**DEQ Coal Combustion Residuals
Surface Impoundment
Closure Determination**

Roxboro Steam Station

April 1, 2019

CROSS SECTION B-B' (VIEWED FROM SE SIDE OF CROSS SECTION LOOKING TO NW)

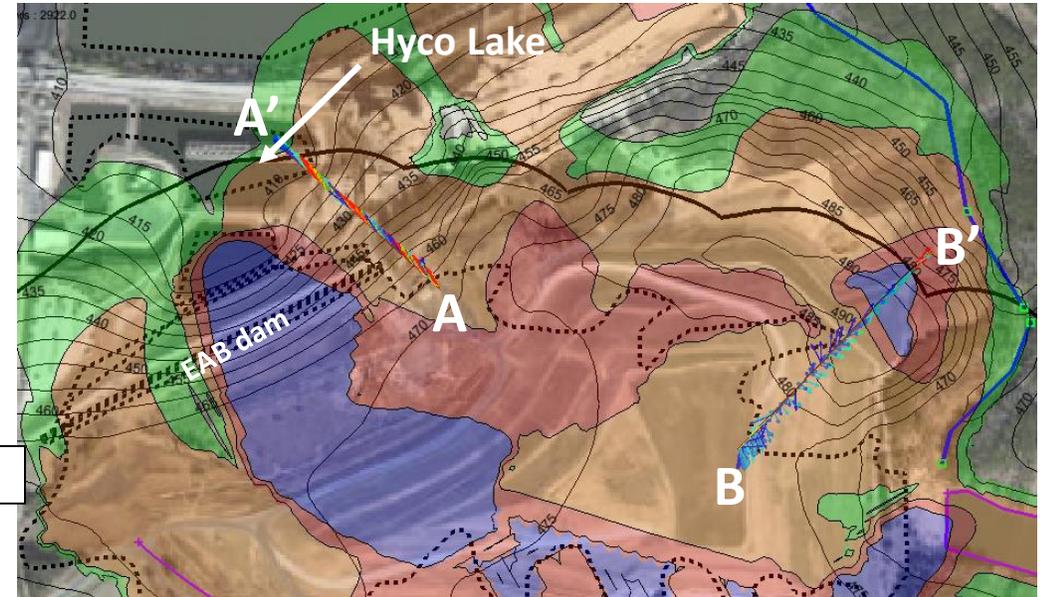
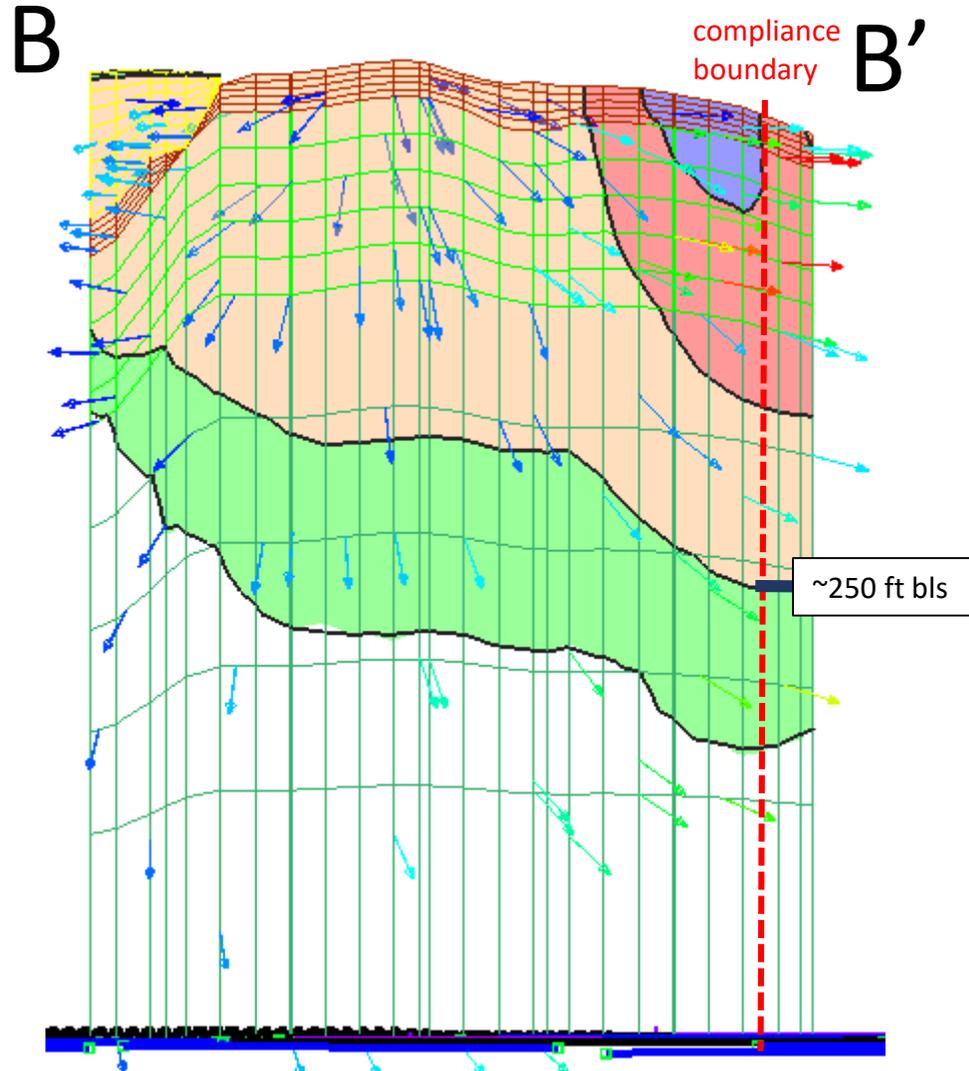
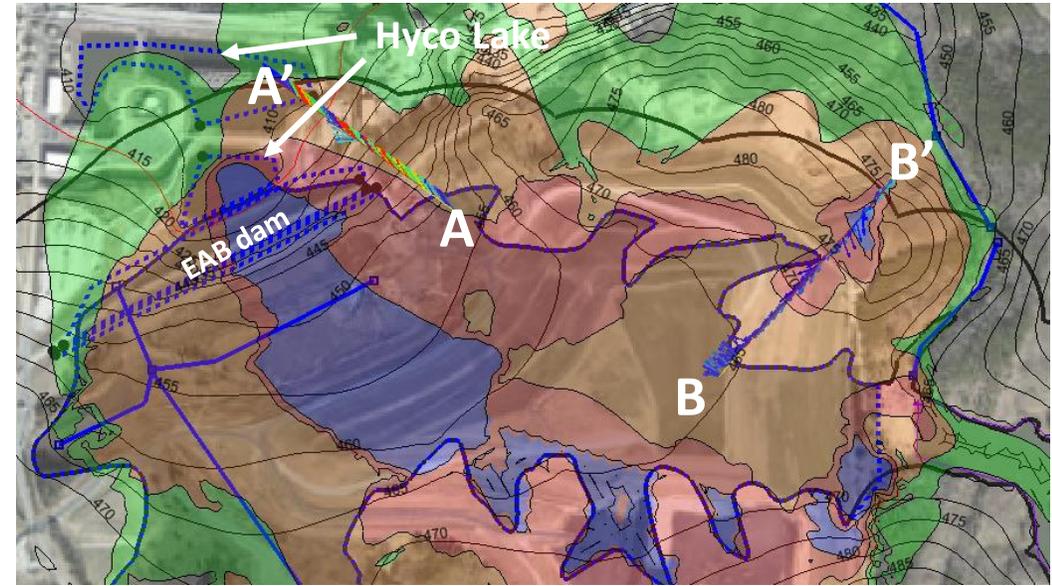
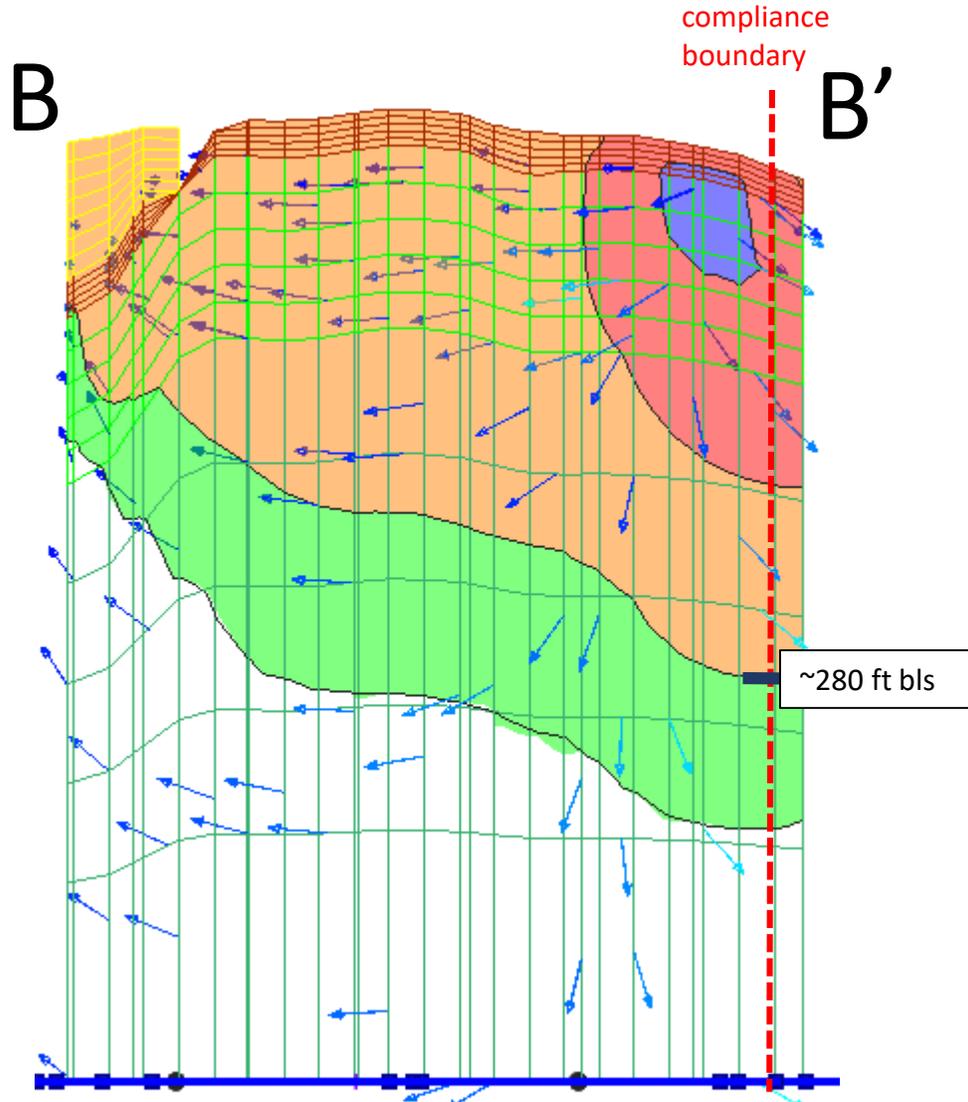
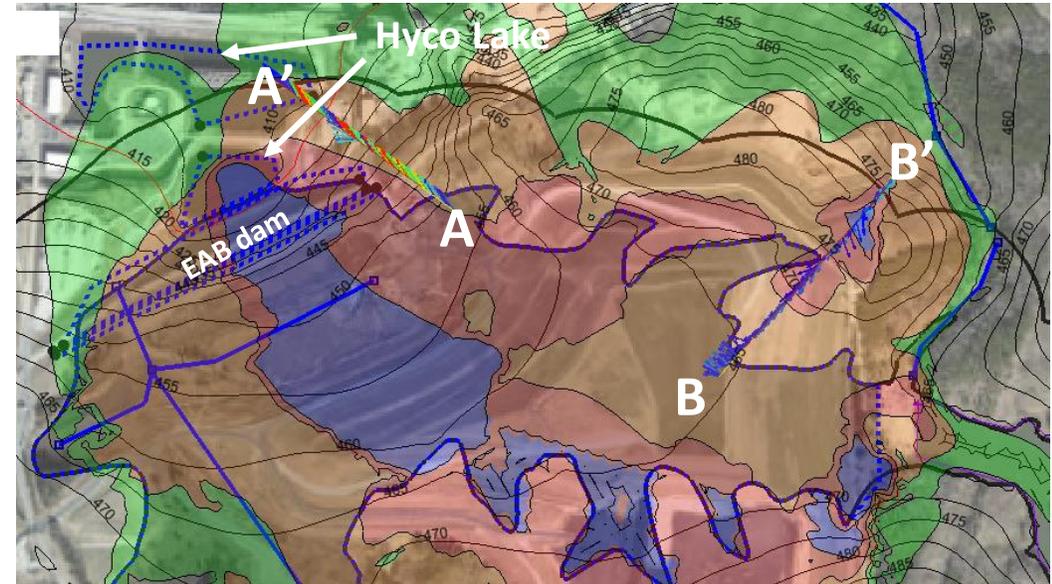
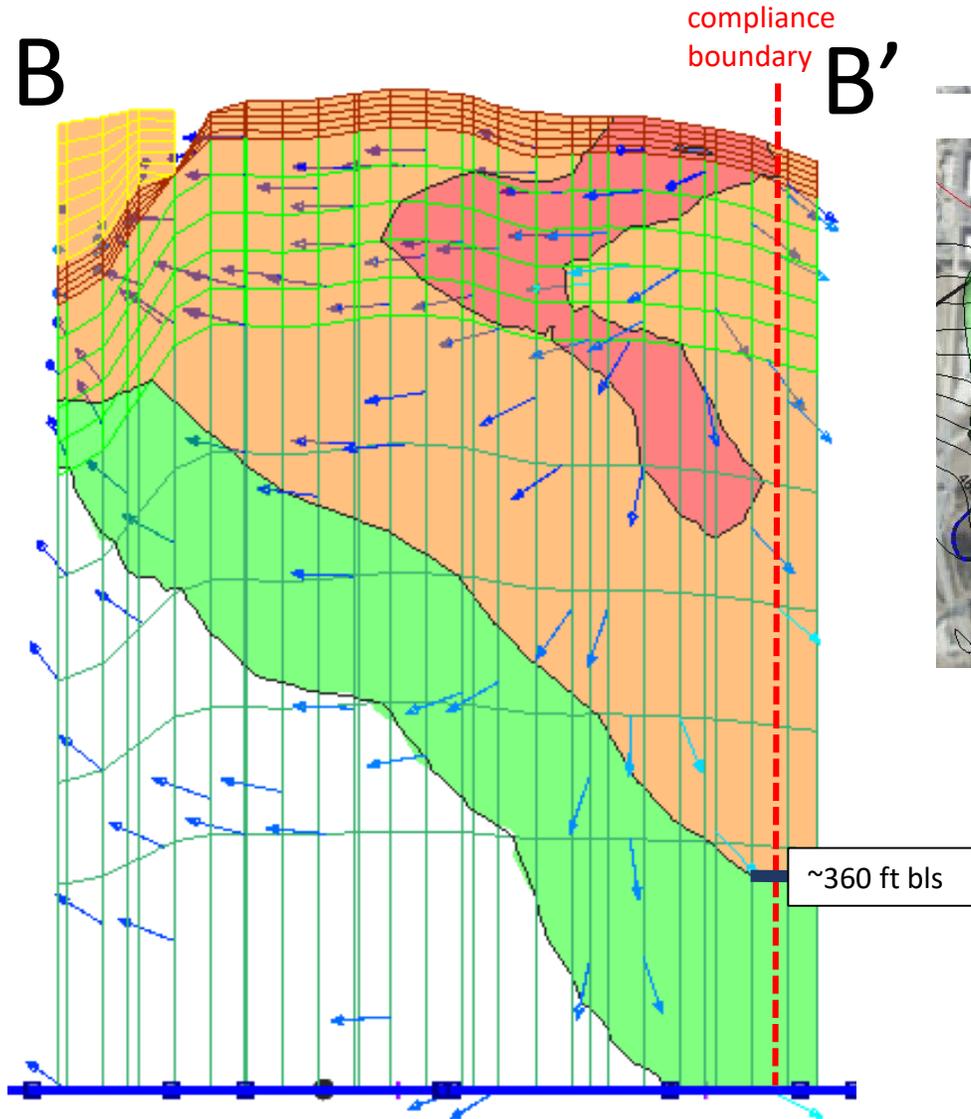
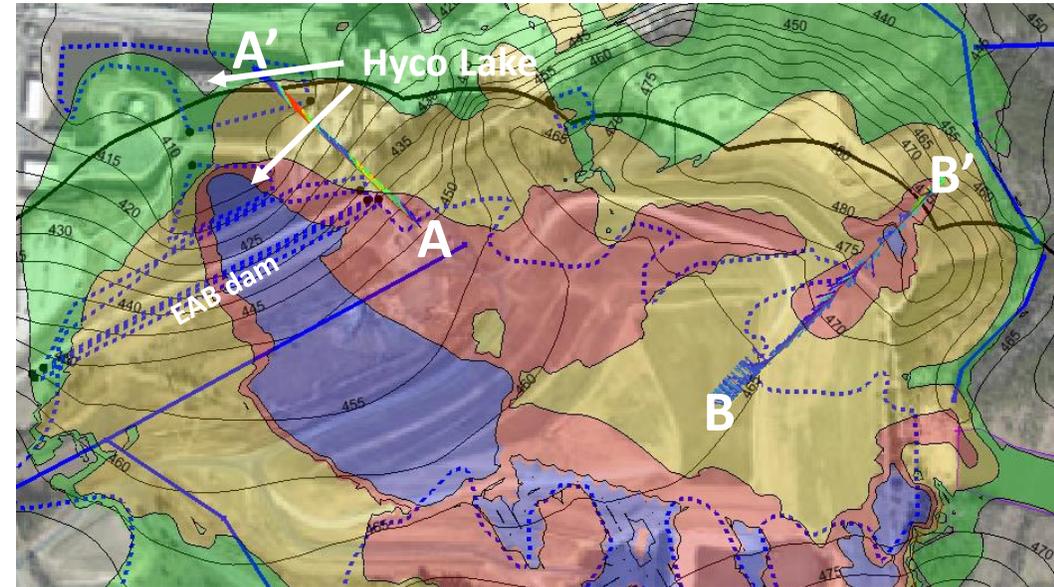
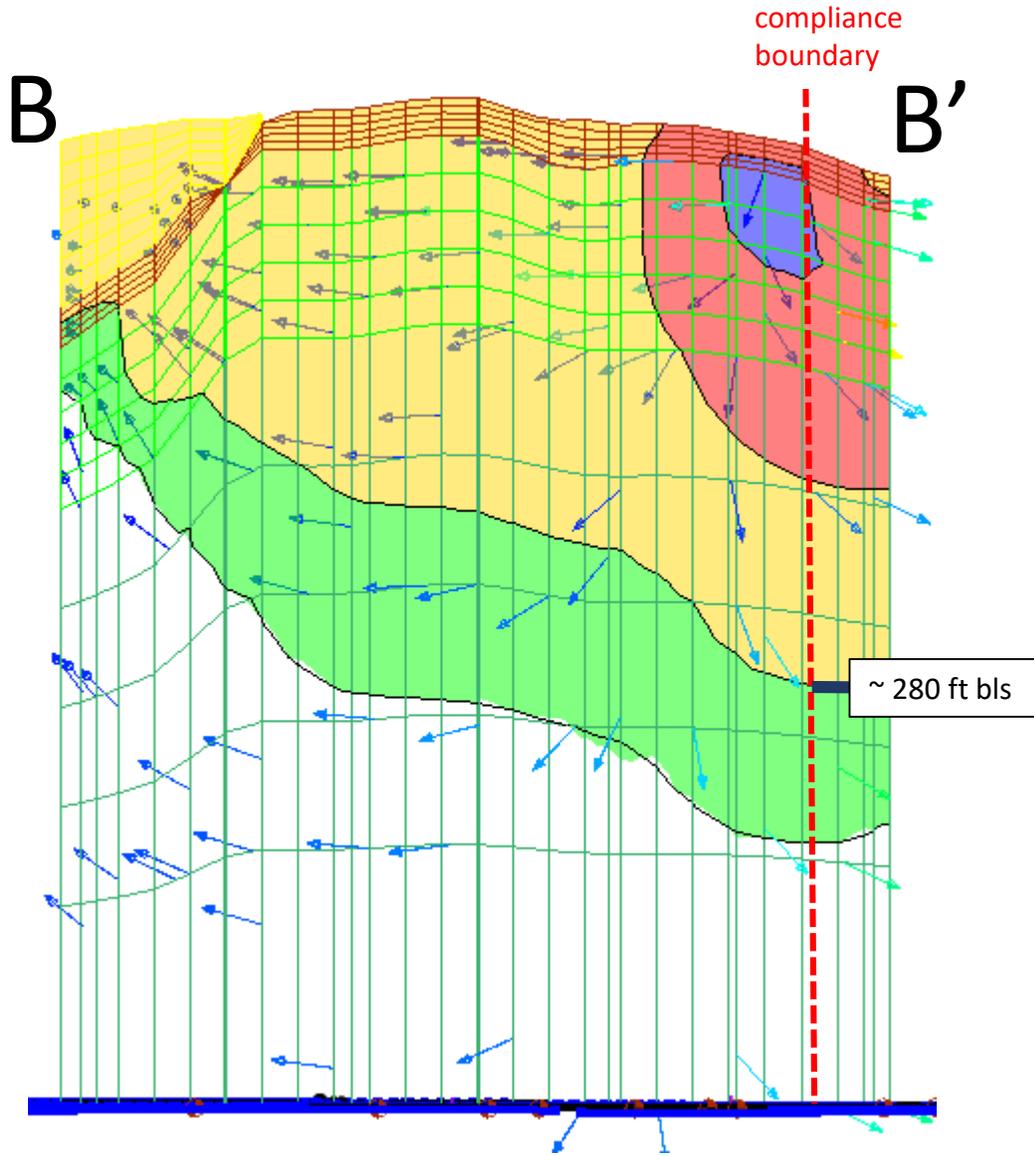
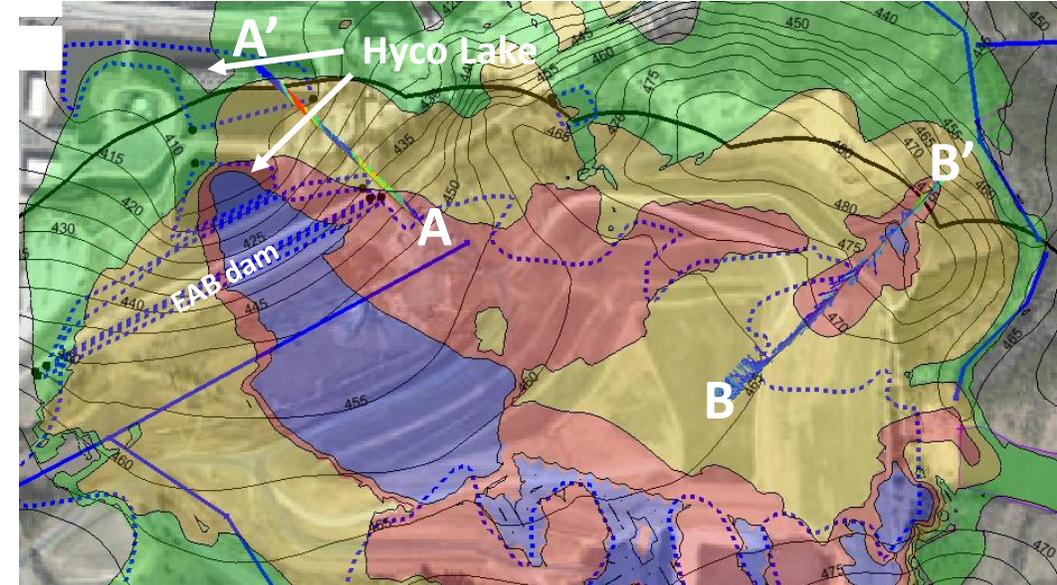
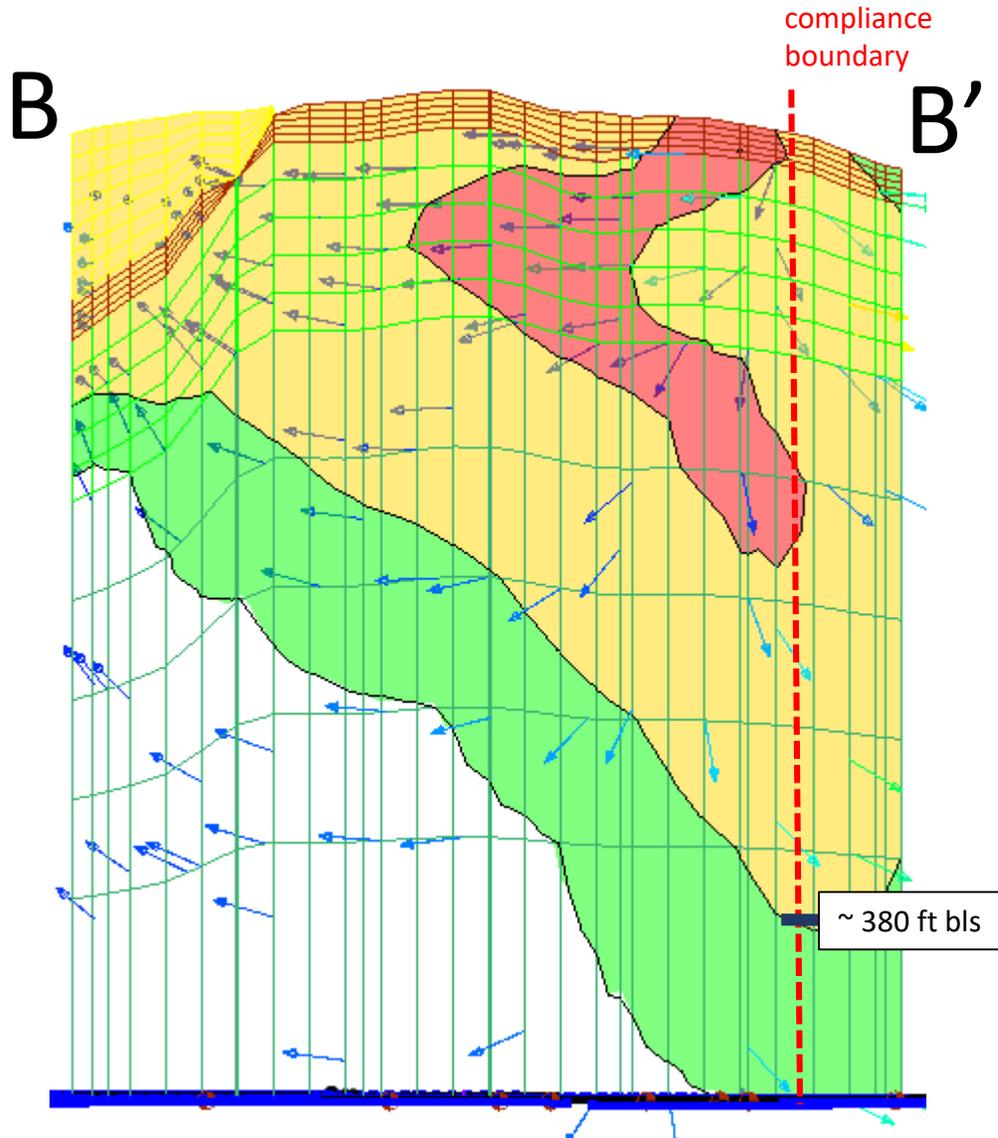
Roxboro Modeling Results for Cross-Section B-B'			
Model Simulation	Maximum Concentration of Boron Above 2L Beyond Compliance Boundary (ug/L)	Depth of GW Contamination Above 2L Beyond Compliance Boundary (feet bgs)	Width of Contamination Plume Beyond Compliance Boundary (feet)
Current Conditions	4,000-10,000	250	2260
Completion of Final Cover (t=0 yrs)	4,000-10,000	280	2290
Final Cover (t=100 yrs)	700-4,000	360	1200
Completion of Hybrid (t=0 yrs)	10,000-40,000	280	2260
Hybrid (t=100 yrs)	4,000-10,000	380	1270

These data illustrate that after completion of closure with the final cover or hybrid option, the groundwater plume still extends beyond the compliance boundary above the 2L groundwater standard and the area of the plume requiring remediation is immense. Even 100 years beyond completion of closure, the area of the plume requiring remediation remains extensive.

DEQ recognizes that there are no groundwater remediation corrective actions included in the groundwater modeling simulations submitted to DEQ as part of Duke Energy's closure options analysis documentation. However, based on the current geographic scope, vertical extent of the groundwater contamination plume, and future modeled extent of the plume, DEQ does not believe these two closure options for the EAB can meet the requirements of CAMA Option B.
